TH-4

client: Zancor Homes
project: Wasaga Townhomes
location: Wasaga Beach
marketing name:

model: TH-4
scale: 3/16" = 1'0"
project #: 16058

SECOND FLOOR ELEV. 'A'

A1

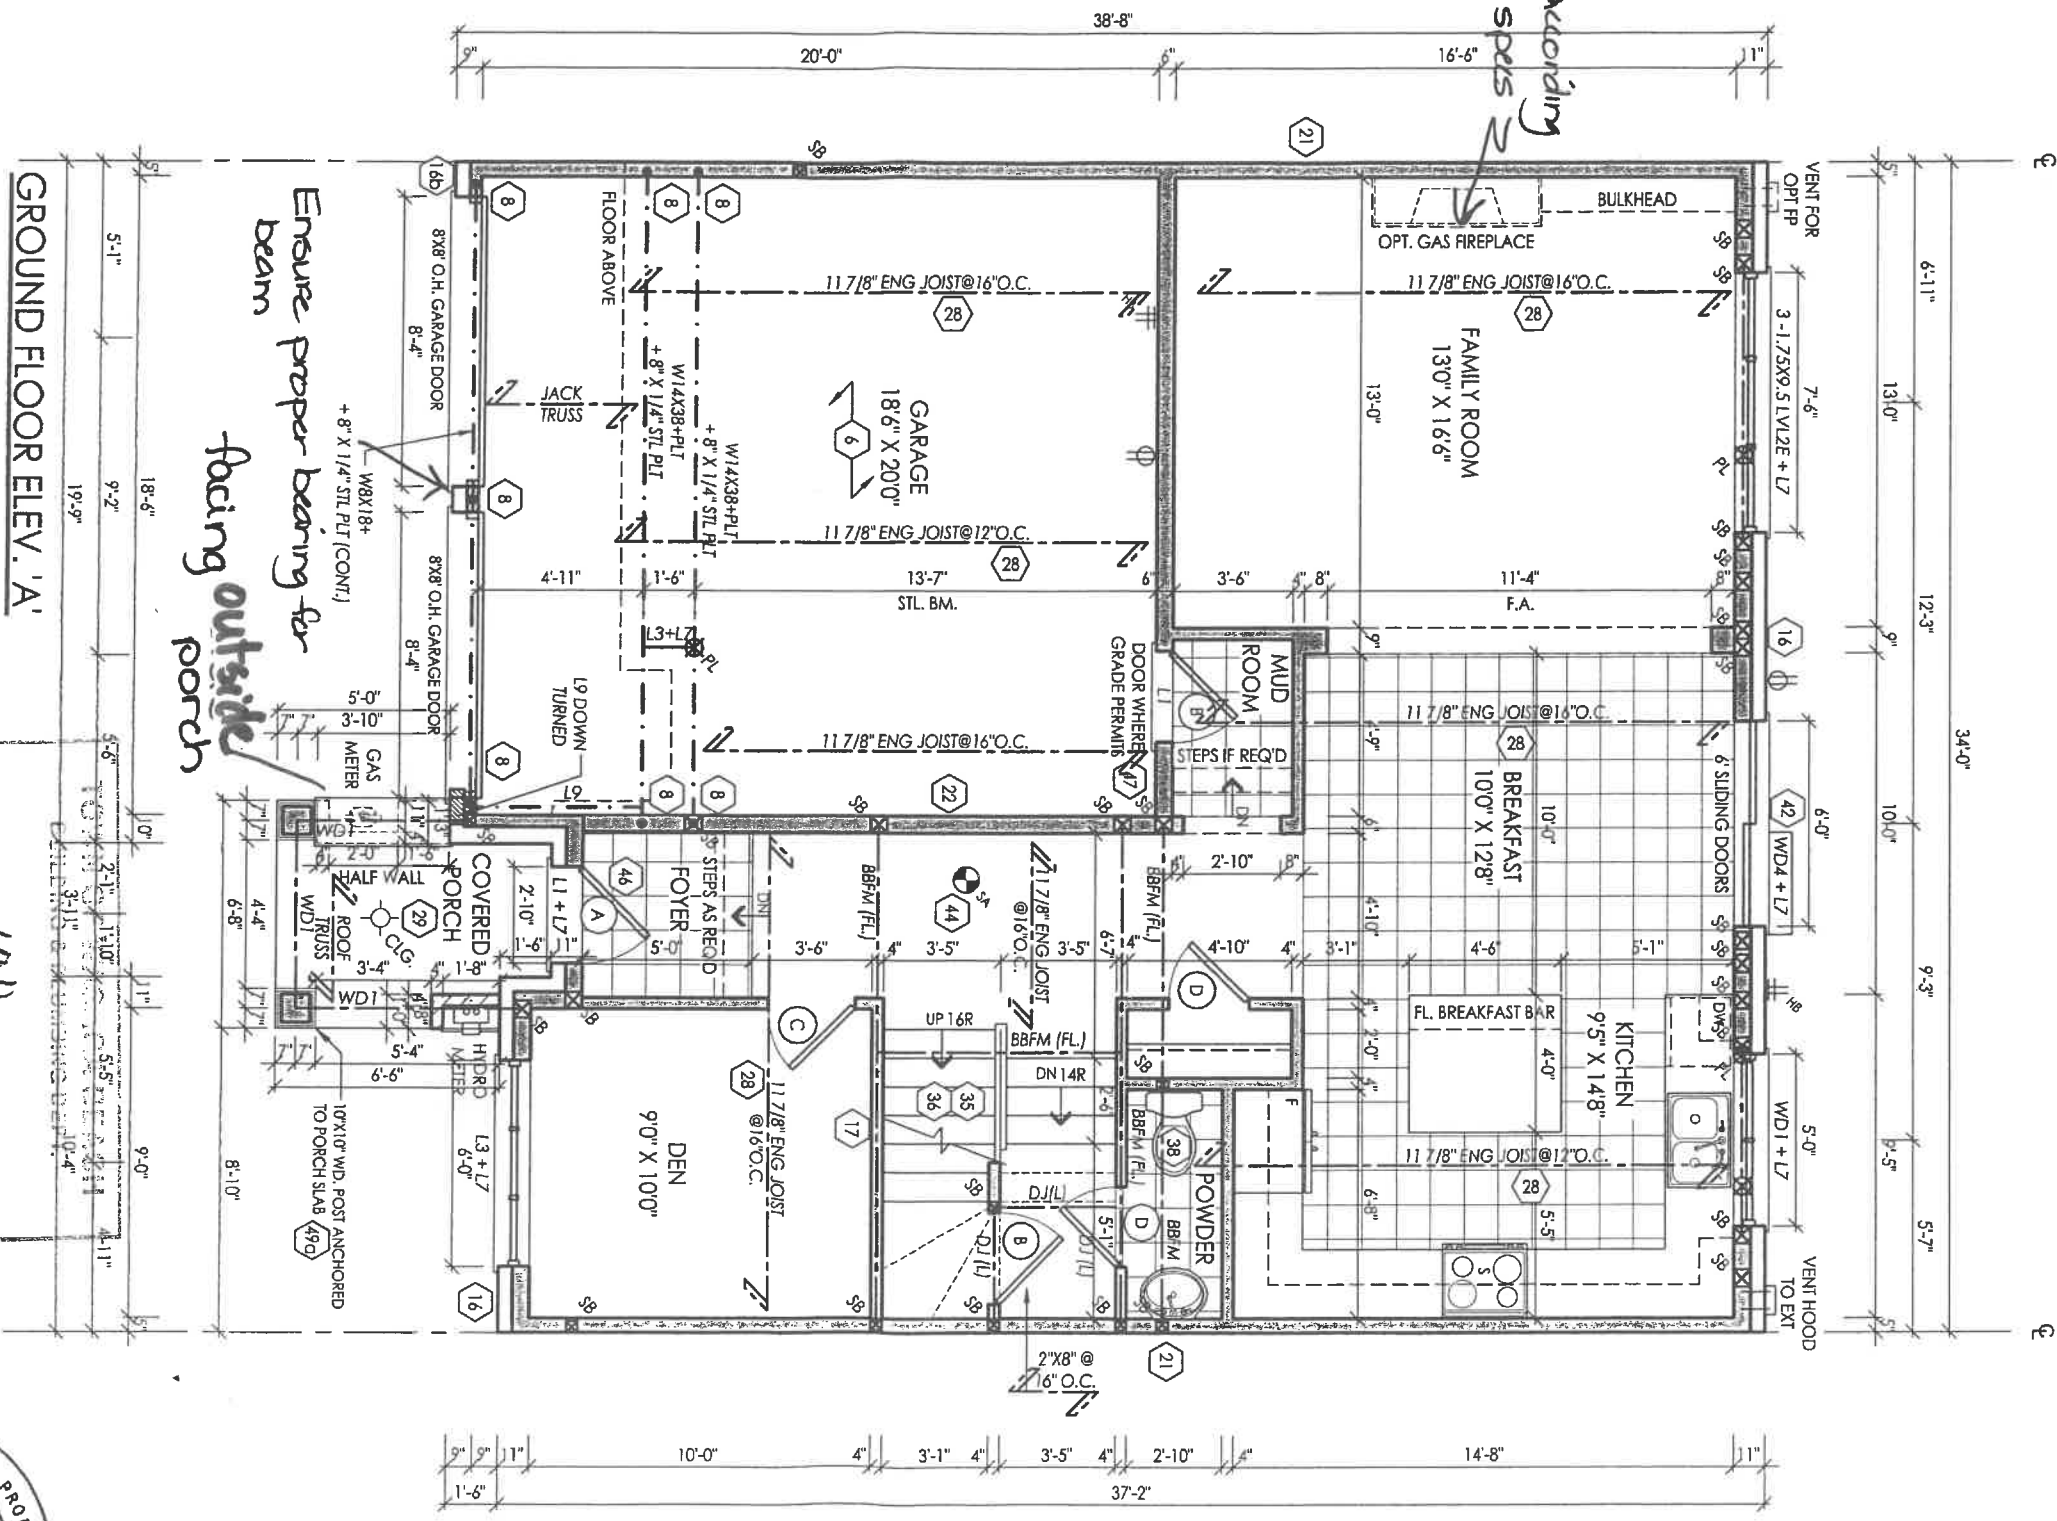
Refer to floor design for joist/beam sizes, spacing and direction

* waterline to be 3/4" from main to footrest bathroom group
